SEQUOYAH NUCLEAR PLANT UNIT 1 AND UNIT 2

IMPROVED TECHNICAL SPECIFICATIONS CONVERSION

ITS SECTION 3.1 REACTIVITY CONTROL SYSTEMS

Revision 0

Figure 3.1.3 - 1 (page 1 of 1)
Moderator Temperature Coefficient Vs. Rated Thermal Power

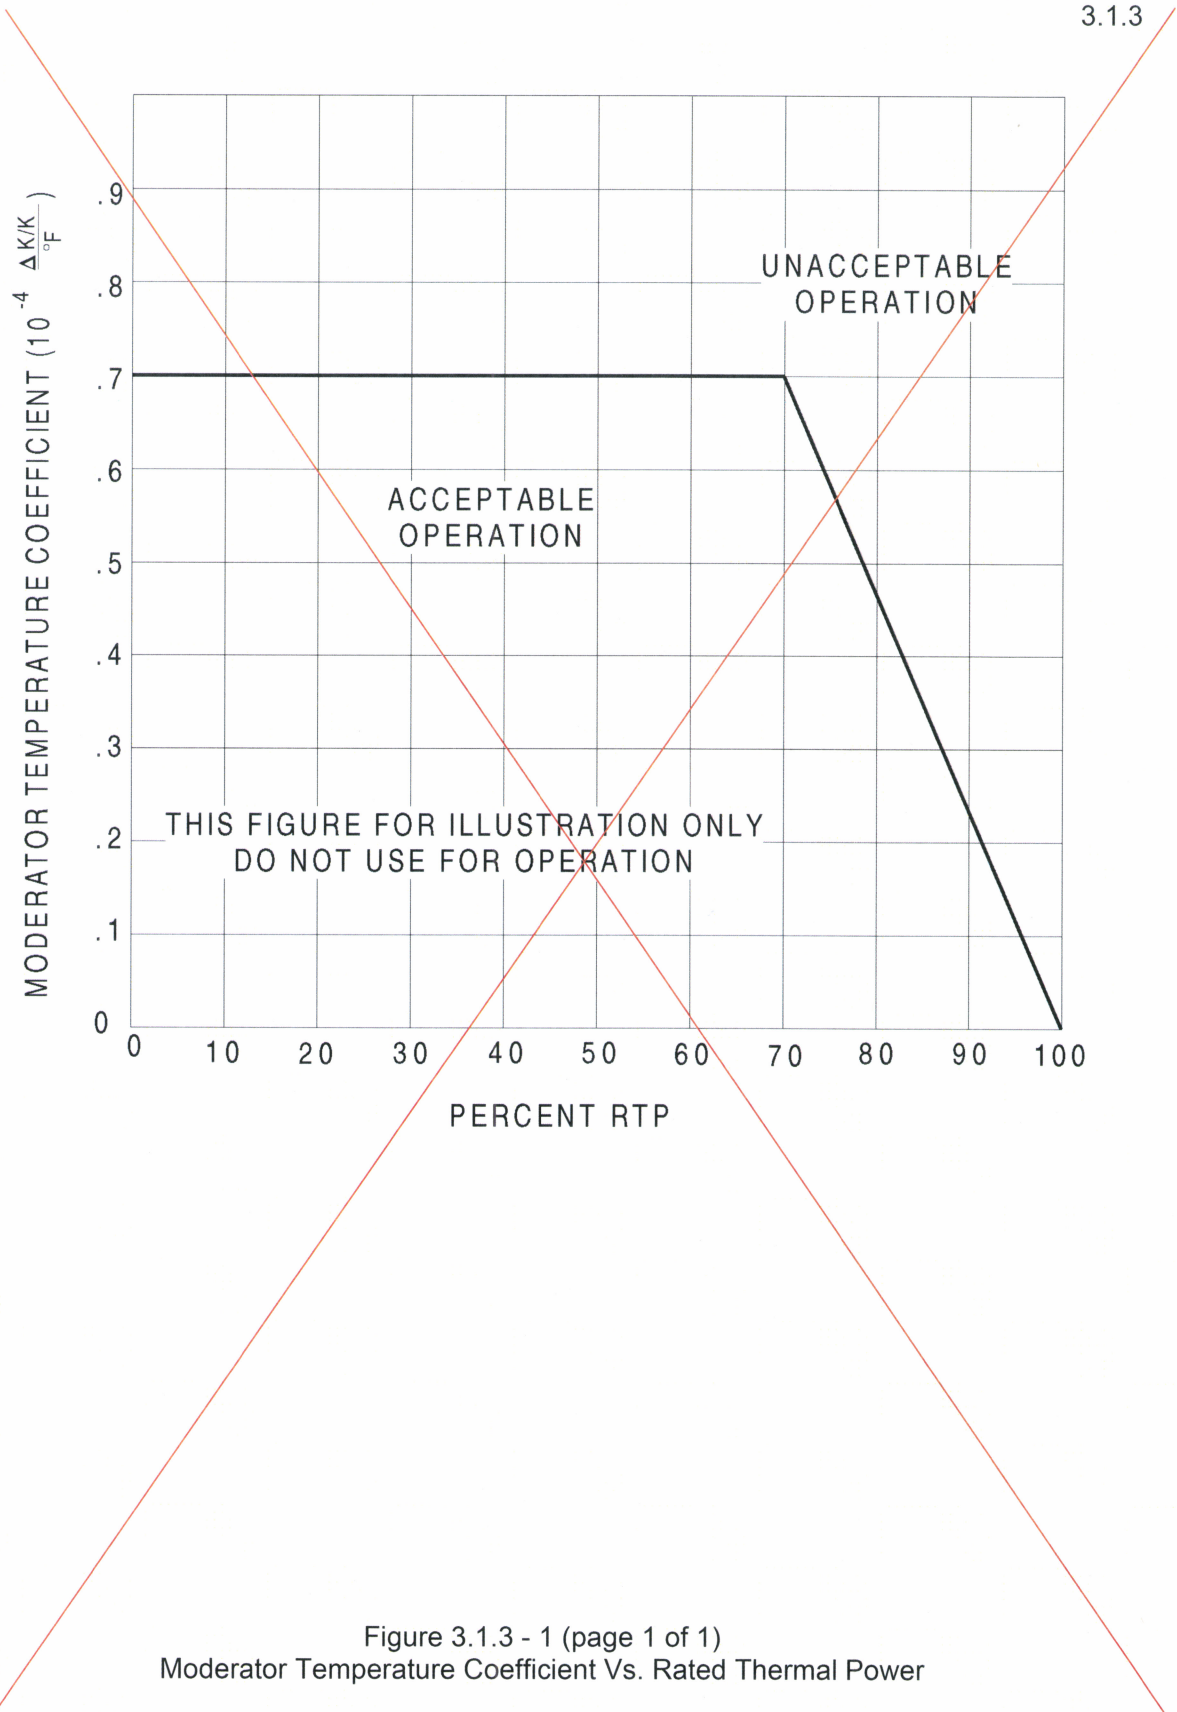
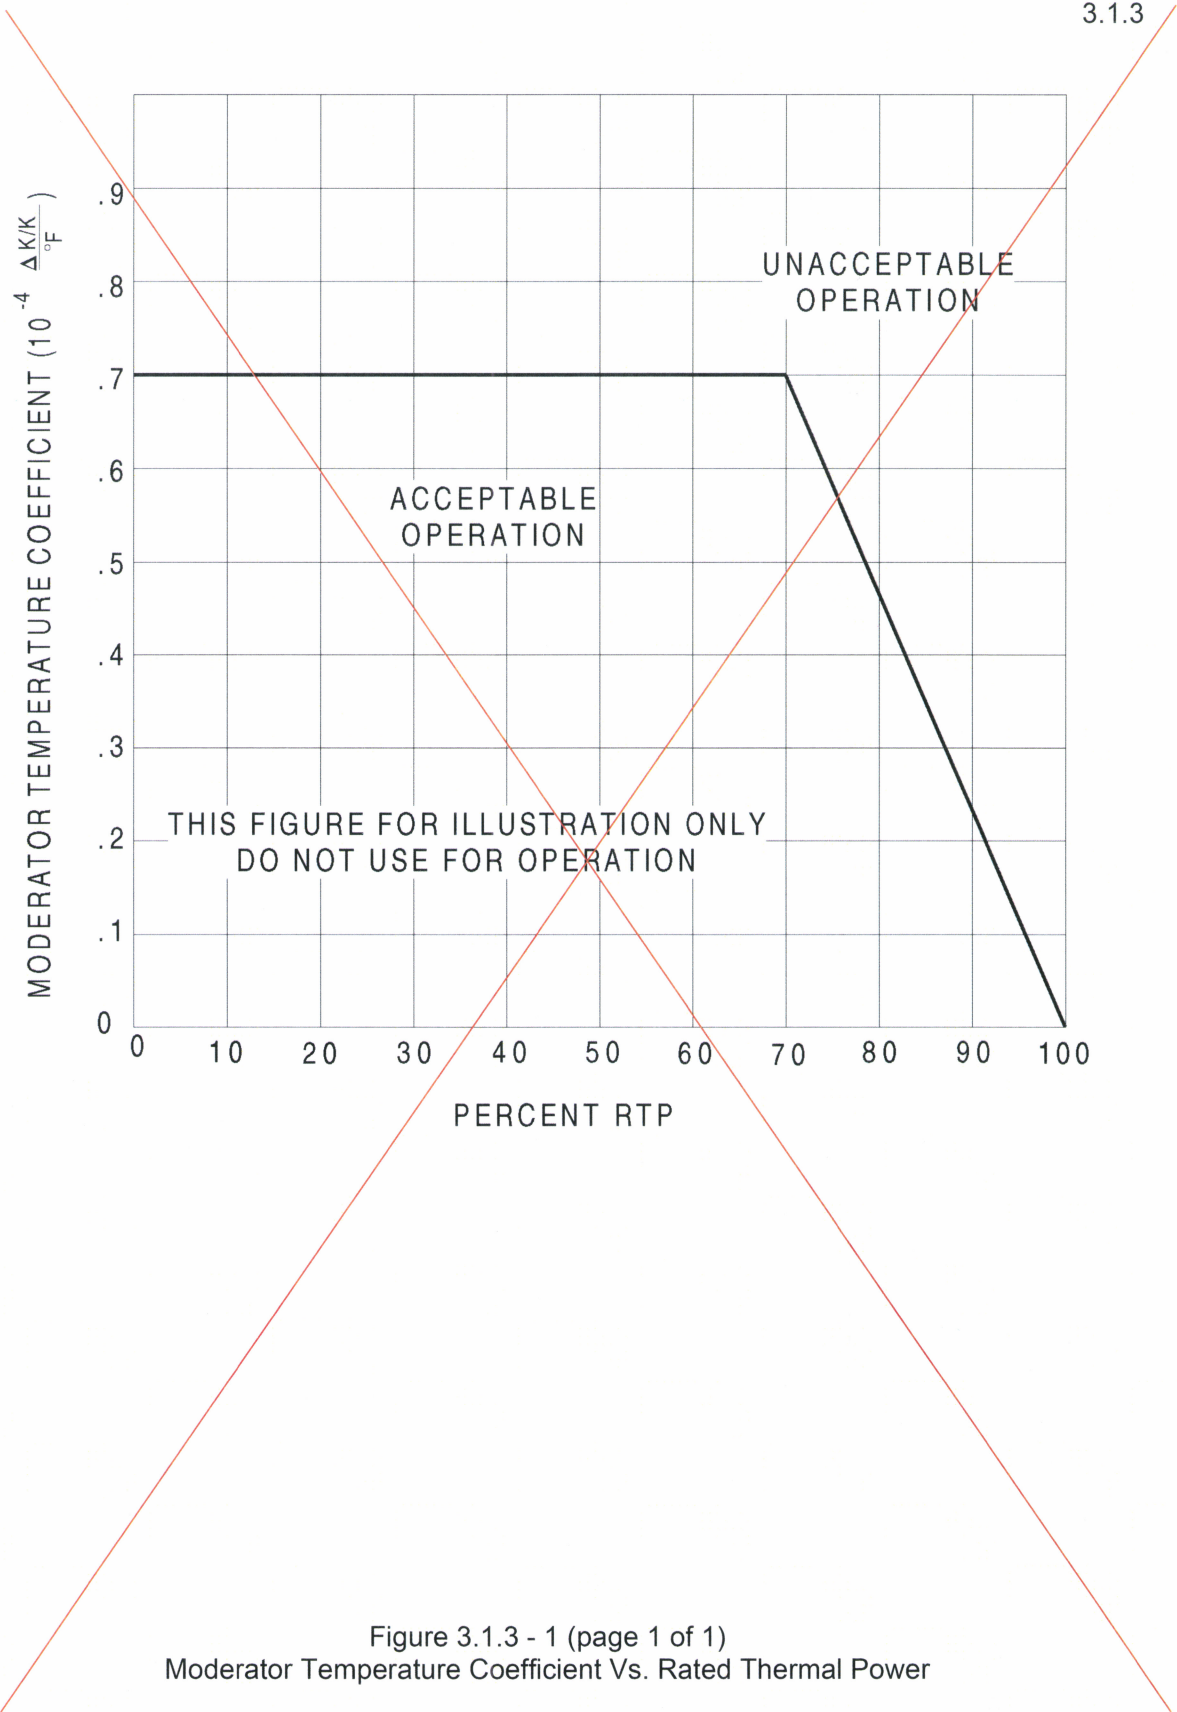
1. The ISTS contains bracketed information and/or values that are generic to Westinghouse vintage plants. The brackets are removed and the proper plant specific information/value is inserted to reflect the current licensing basis.
2. Changes are made (additions, deletions, and/or changes) to the ISTS that reflect the plant specific nomenclature, number, reference, system description, analysis, or licensing basis description.
3. ISTS 3.1.3 contains Figure 3.1.3-1 for Moderator Temperature Coefficient Vs Rated Thermal Power. This figure is not maintained in ITS 3.1.3. ITS 3.1.3 lists the maximum upper limit value in the LCO. Therefore, ISTS Figure 3.1.3-1 is not required and has been deleted.

Figure B 3.1.6 (page 1 of 1)
Control Bank Insertion vs. Percent RTP

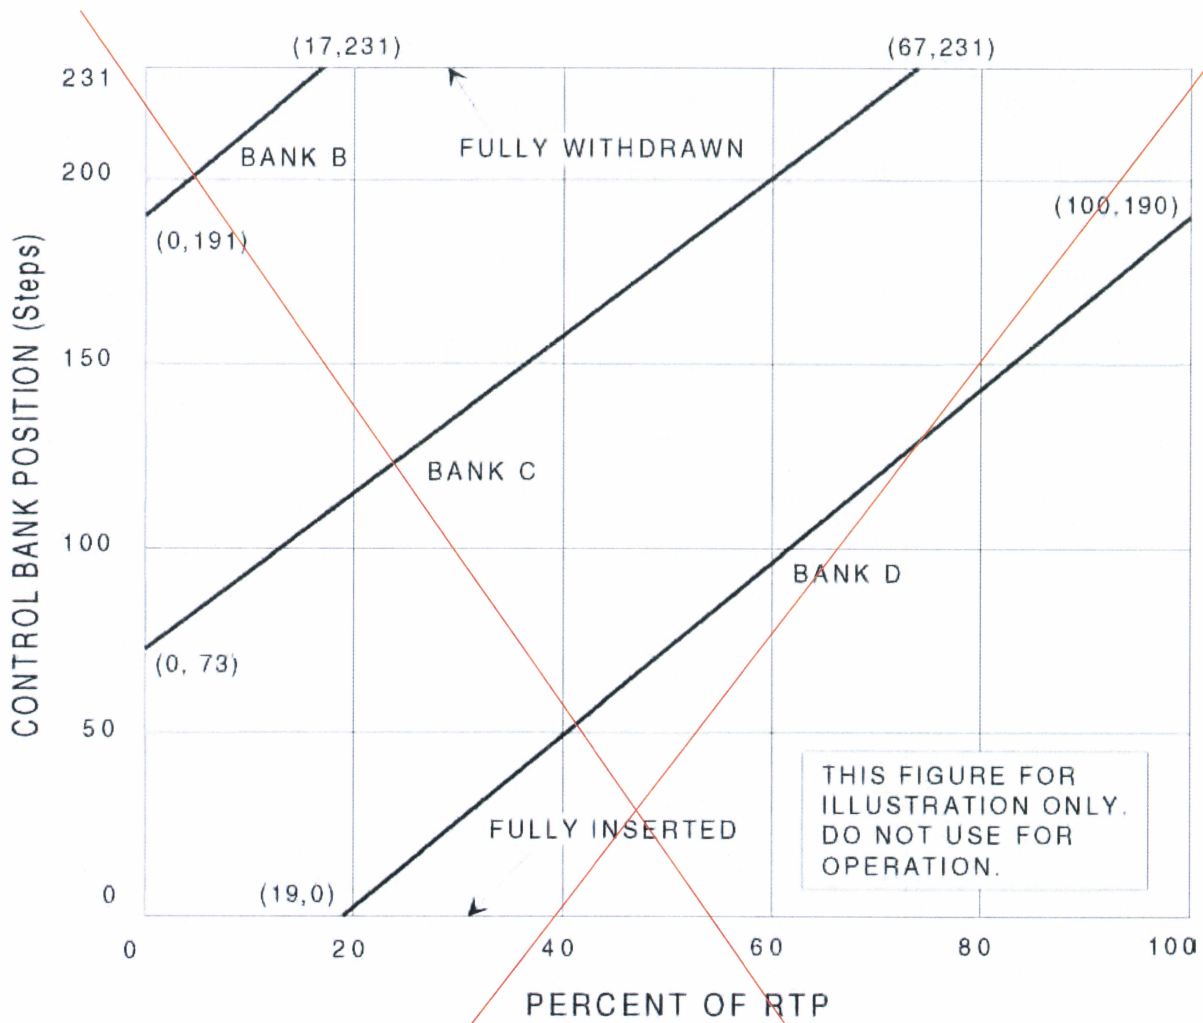
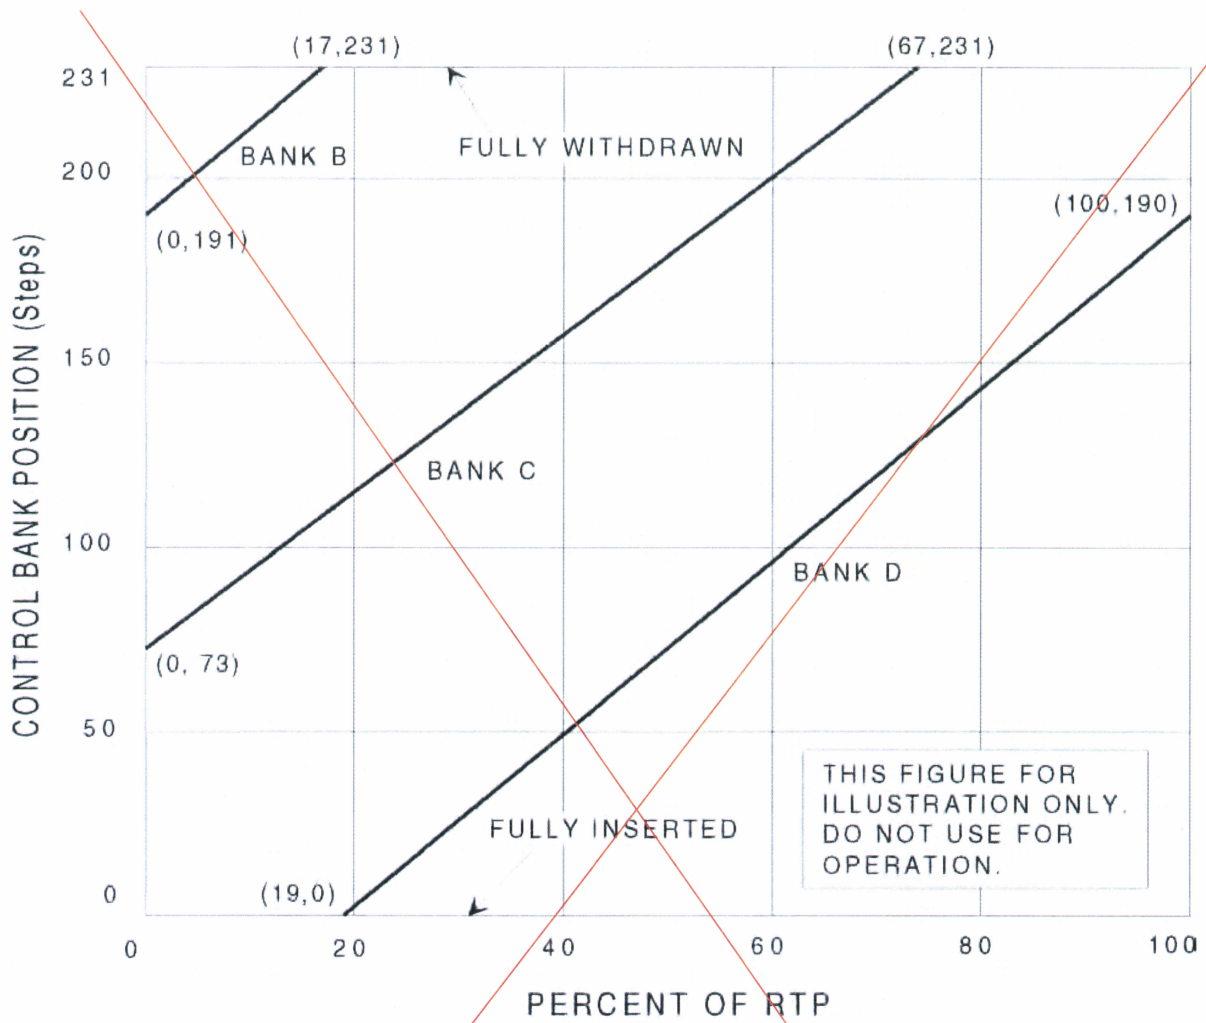
2. ISTS 3.1.6 contains Figure B 3.1.6-1 and states that it is an example provided for information only. ITS 3.1.6 does not include Figure B 3.1.6-1. The control bank insertion limits for Sequoyah Nuclear Plant (SQN) are located in the COLR. Therefore, ISTS Figure B 3.1.6-1 and the references to the ISTS Figure B 3.1.6-1 have been deleted.
